Product Change Notification – PCN # PCN000525.

Subject: Micron Flash and SD Card phase out for NPort 6450 series.

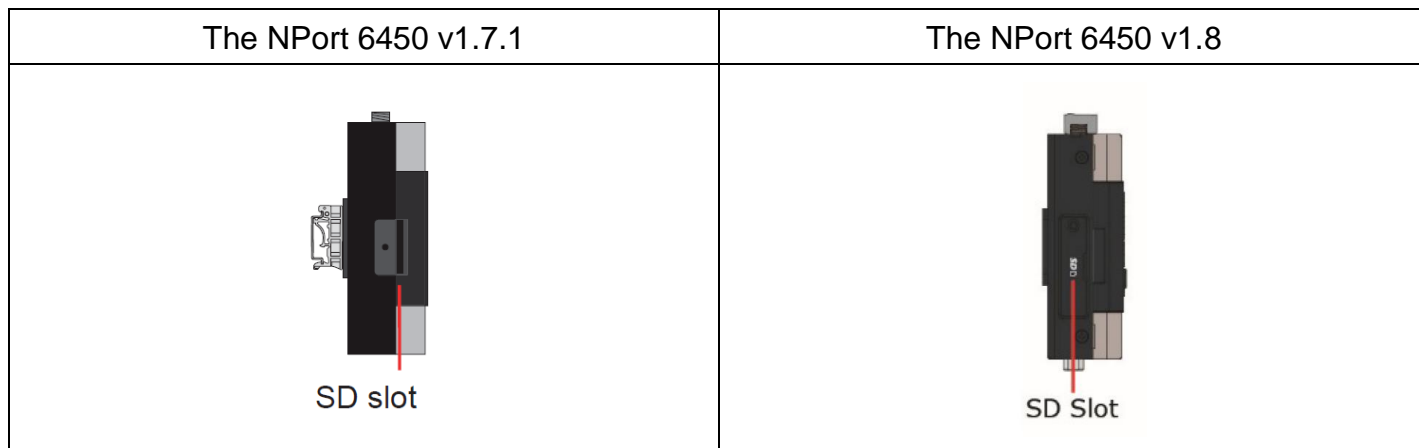
The Micron Flash and SD Card of NPort 6450 Series has been phased out due to the vendor's roadmap planning. It will be replaced with another components, performing the same functions.

The SD Card connector's position will be changed and add a plate before SD Card connector.
